STAFF RECOMMENDATION
201 Second Avenue North
February 17, 2021

Application: New Construction—Addition; Violation
District: Second Avenue Historic Preservation Zoning Overlay
Council District: 19
Base Zoning: DTC
Map and Parcel Number: 09302400900
Applicant: Ajeya Upadhyaha
Project Lead: Robin Zeigler, robin.zeigler@nashville.gov

<p>Description of Project: The applicant has constructed a rooftop addition with two stair towers, railings, and decks without permits.</p> <p>Recommendation Summary: Staff recommends approval of the rooftop addition with the conditions that:</p> <ol style="list-style-type: none">1. A cornice, to be approved administratively, be added to the 2nd Ave N and Church Street facades within 180 days using the cornice from the building that used to be at 200 2nd Avenue as an inspiration;2. The rooftop additions be clad in stucco;3. MHZC staff approve doors prior to their purchase and installation; and,4. The rooftop element have no additional lighting, signage or other features installed without a Preservation Permit. <p>With these conditions, the application will meet section III.H (New Construction—Additions). If the cornice is not installed, staff recommends r

Figure 2: Rooftop plan showing the areas of decking, railing and two stair towers.

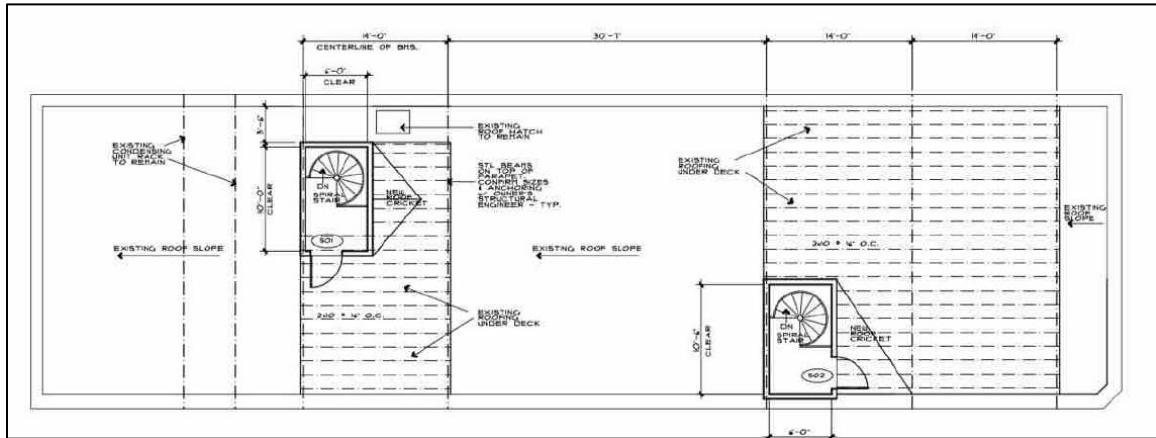
The tallest feature of the addition is the two stair towers that are eleven feet (11’) tall. The addition does not exceed one story and so meets section III.H. 5

Both stair towers, should step back at least thirty feet (30’) from the Second Avenue side and ten feet (10’) from the Church Street side. One of the towers meets these step backs

but one does not. That tower is only twenty-two feet (22') from Second Avenue and is stacked on the Church Street side wall.

In most cases, the Commission has required a railing, deck, and associated features to step back from the edge of a building at least eight feet (8'). In this case, there is railing three and one-half feet from Second Ave N and on the wall of the Church Street side in two places. The project does not meet section III.H.5

1. A cornice, to be approved administratively, be added to the 2nd Ave N and Church Street facades within 180 days using the cornice from the building that used to be at 200 2nd Avenue as an inspiration;
2. The rooftop additions be clad in stucco;
3. MHZC staff approve doors prior to their purchase and installation; and,
4. The rooftop element have no additional lighting, signage or other features installed without a Preservation Permit.

Figure 5: The rooftop addition as seen from the rear deck, looking towards the front of the building.

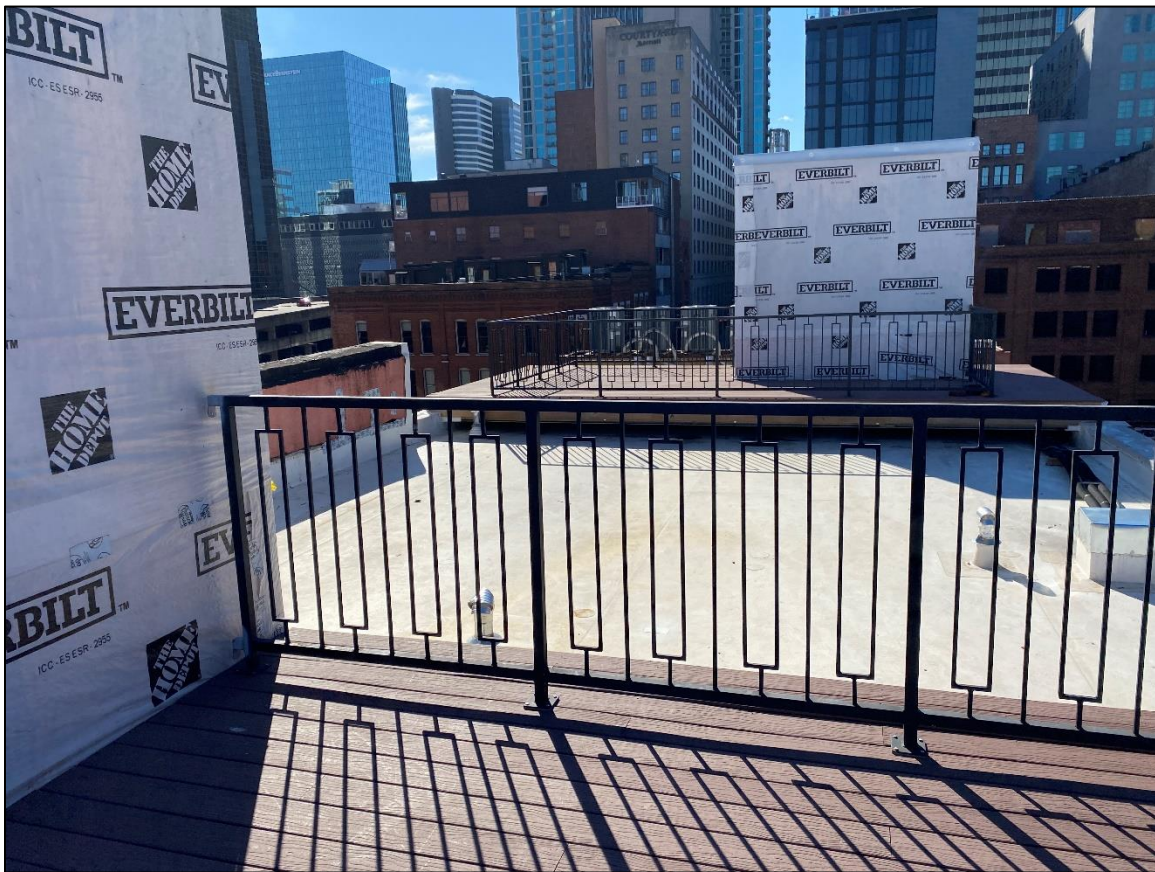
The stair towers are proposed to be clad in cedar shakes and copper siding. Copper siding is sheets of flat, seamed, or tiled copper used as cladding for a wall. The railing is metal and the decking is a composite decking similar to what has been approved on other rooftop deck areas. Copper siding and cedar shakes are not typical materials for commercial buildings. Staff recommends that the towers are clad in stucco which is the most appropriate cladding material historically. The roofing material is proposed to be a single-ply membrane material which is appropriate for a low-sloped roof. Doors are not indicated. With the condition that the tower cladding will be stucco, and staff approve the doors, the new construction will meet section III.H for Additions—Materials.

Exhibit 1
Portion of sheet 7 showing plan of proposed access

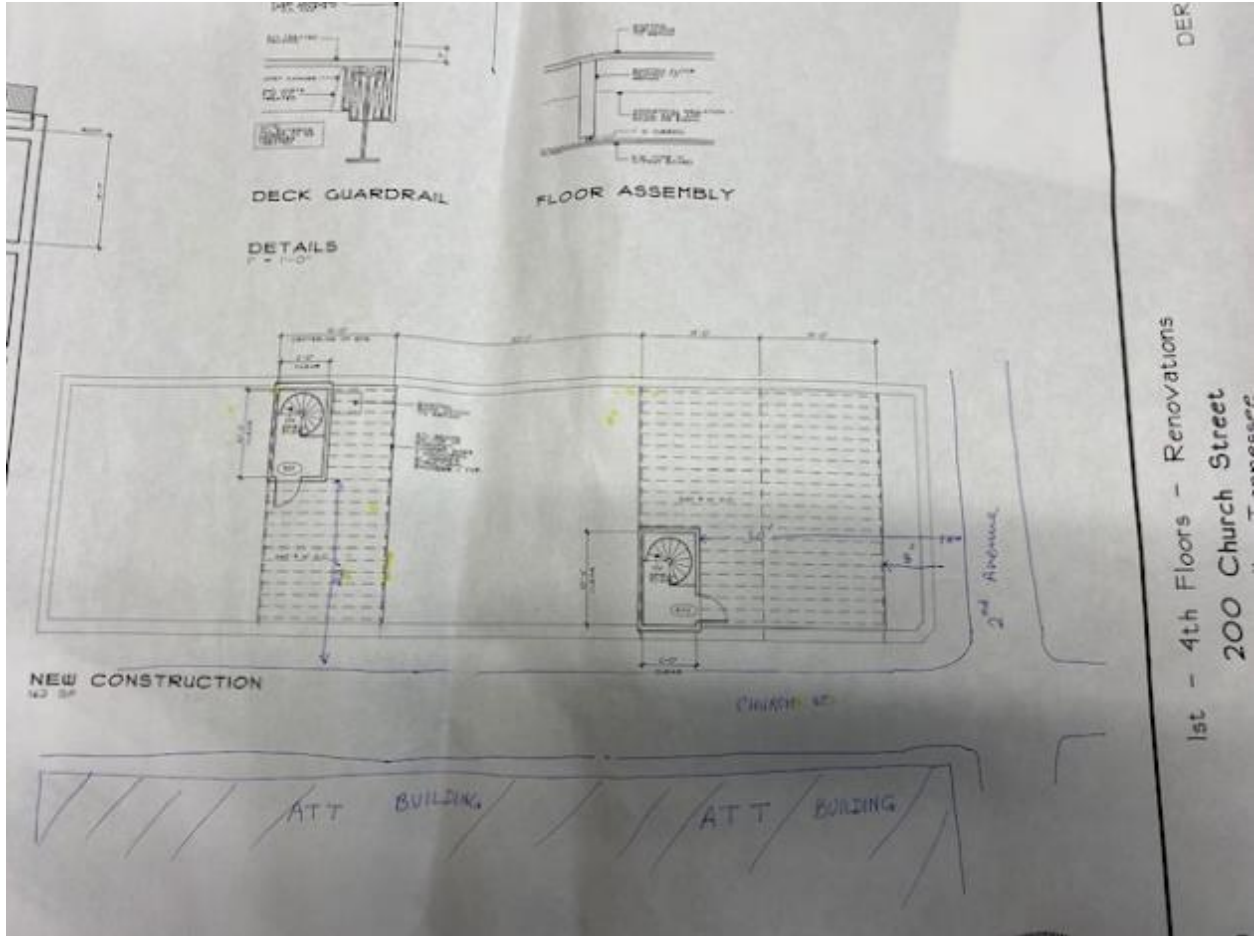
Two access rooms above the spiral stairs landings were constructed in accordance with the drawings prepared by Derek Leigh, AIA and approved by Metro Codes Department permit No 2018049568. The size of the access rooms are 6x10 feet. No work on siding has been performed. The drawings show elevation and plan of rooftop access.

Access room 1 in the back of the building is compliant. We prefer a siding consisting of copper (change to patina) on the lower half and natural cedar shakes in upper part. This is what is shown in the current drawings. As you know the access room is 60 feet from the street level and not visible to pedestrians. We wanted for it to look upscale as well as historical to people on the rooftop.

Access room two does not meet the requirements of 20 feet from secondary street (Church Street). This access room cannot be moved as it is situated on top of spiral stairs. We are requesting the Commission to permit us to keep this room as constructed. The access room and the adjoining railing is on the side where it faces the non-historic ATT building. Because of the size of the ATT building, the room's visibility is limited. We are willing to put any siding you recommend but again please consider copper/natural cedar shake as a historical and upscale look.
